**PLANNED UNIT DEVELOPMENT
& SUBDIVISION STAFF REPORT****Date: July 6, 2006**

DEVELOPMENT NAME Eastridge Place Subdivision, Resubdivision of Lots 14 & 15

CONTEMPLATED USE Planned Unit Development Approval to amend a previously approved Planned Unit Development Approval to remove a side yard setback line, and Subdivision Approval to combine two lots into one lot.

SITE PLAN

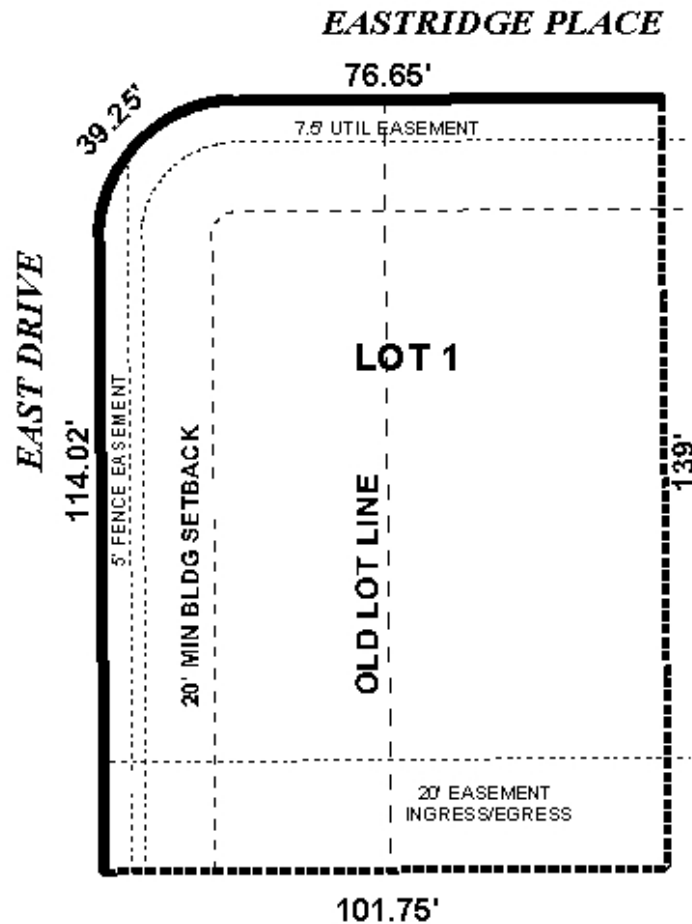
The applicant is requesting to combine two existing lots into one lot, and amend an existing Planned Unit Development (PUD) approval to change required building setback lines.

The record plat requires the following setbacks for Lot 14: front – 20 feet, East side – 0 feet, West side – 8 feet; rear – 20 feet. The record plat requires the following setbacks for Lot 15: front – 20 feet, East side – 0 feet, West side (street) – 20 feet, rear – 20 feet. With the combining of Lots 14 and 15 into one lot, the applicant proposes to have the new setbacks as follows: front – 20 feet, East side – 0 feet, West side (street) – 20 feet, rear – 20 feet. Standard setbacks in an R-1, One-Family Residential District are as follows: front – 25 feet, side – 8 feet, side (street) – 20 feet, rear – 8 feet. Subdivision approval is required to modify these setbacks on the record plat, and PUD approval is required to allow reduced setbacks.

The applicant currently lives on Lot 14, and is making this request to allow the construction of a pool on Lot 15, however, regulations do not allow for the construction of a pool on a lot of record without an accompanying primary structure. The combination of the two lots by the subdivision process will allow the applicant to proceed with the construction of the pool for his existing residence. The applicant will maintain all other setbacks, including the 20-foot ingress-egress easement located at the rear of the property. The applicant is not proposing to change the existing maximum site coverage of 35% for the property.

Planned Unit Development: Based upon the preceding, this application is recommended for approval subject to the following condition: 1) completion of the subdivision process; 2) placement of a note on the site plan and final plat stating that all common areas to be maintained by the property owners association; 3) placement of a note on the site plan and final plat stating that the maximum building site coverage shall not exceed 35% ; 4) placement of the following note on the site plan and final plat – *“Preservation status granted for all 50-inch and larger trees. All work under the canopies is to be permitted and coordinated with Urban Forestry, removal to be permitted by Urban Forestry only in the case of disease or impending danger”*; 5) placement of a note on the site plan and final plat stating that no permanent structures, such as buildings or pools, may be placed in easements; and 6) full compliance with all other municipal codes and ordinances.

Subdivision: The plat meets the minimum requirements of the Subdivision Regulations and is recommended for Tentative Approval subject to the following conditions: 1) placement of a note on the site plan and final plat stating that all common areas to be maintained by the property owners association; 2) placement of a note on the site plan and final plat stating that the maximum building site coverage shall not exceed 35% ; 3) placement of the following note on the site plan and final plat – *“Preservation status granted for all 50-inch and larger trees. All work under the canopies is to be permitted and coordinated with Urban Forestry, removal to be permitted by Urban Forestry only in the case of disease or impending danger”*; 4) placement of a note on the site plan and final plat stating that no permanent structures, such as buildings or pools, may be placed in easements; and 5) full compliance with all other municipal codes and ordinances.
